**1.2 270 CLAYTON ROAD, CLAYTON
USE OF LAND AS A RESIDENTIAL HOTEL (SERVICED APARTMENTS) AND
CONSTRUCTION OF A MULTI-STOREY MIXED USE BUILDING AND REDUCTION OF
THE CAR PARKING REQUIREMENT
(TPA/51795)**

EXECUTIVE SUMMARY:

This application proposes an 11 storey mixed use development comprising retail tenancy, office floor space and 104 serviced apartments supported by 120 car parking spaces in four levels of basement.

Figure 1 - Extract of Clayton Activity Centre Built Form Plan

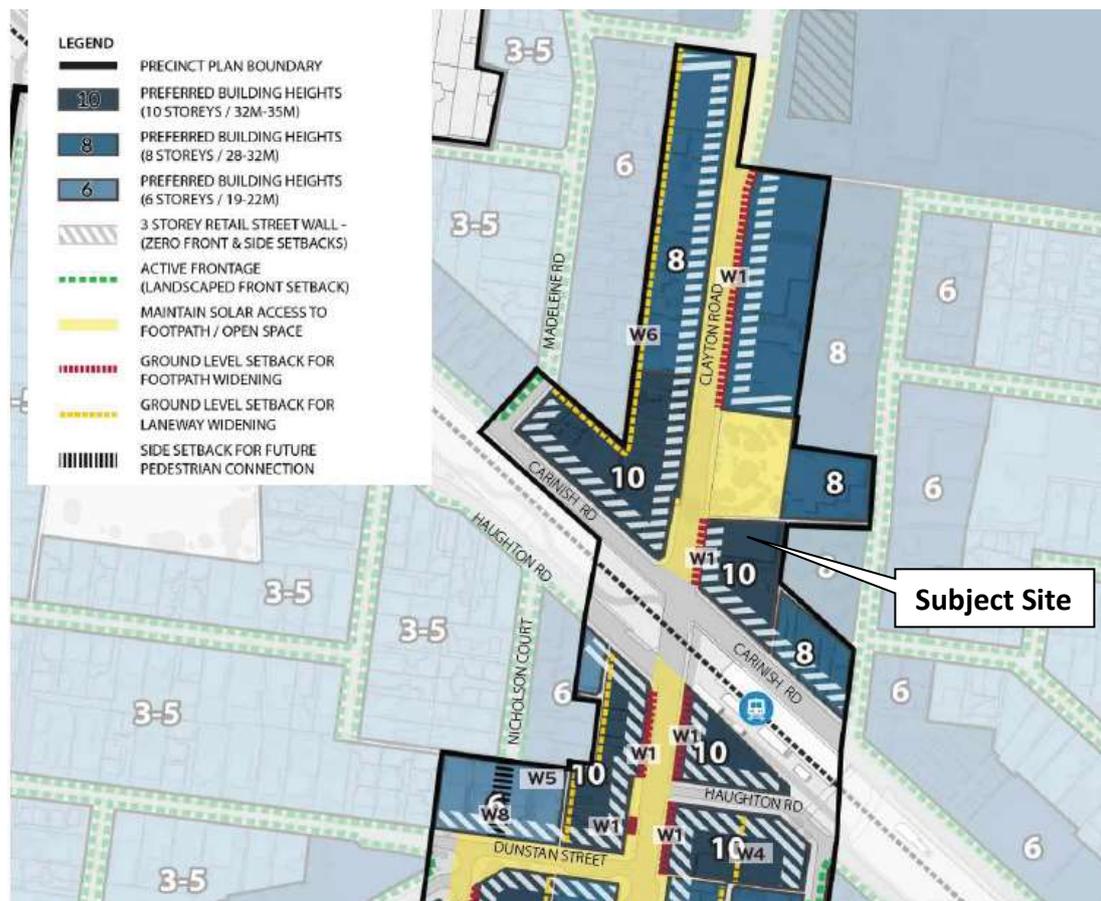
The proposed development with maximum building height of 41.24 metres (11 storeys) significantly exceeds the preferred maximum building height of the Precinct Plan.

Although conceptually, a higher density development is supported on the subject site given it is a key redevelopment site, the concern with the current proposal surrounds its scale, its impact on the surrounding street network and residential neighbourhood and the urban design outcomes will be discussed in the balance of this report.
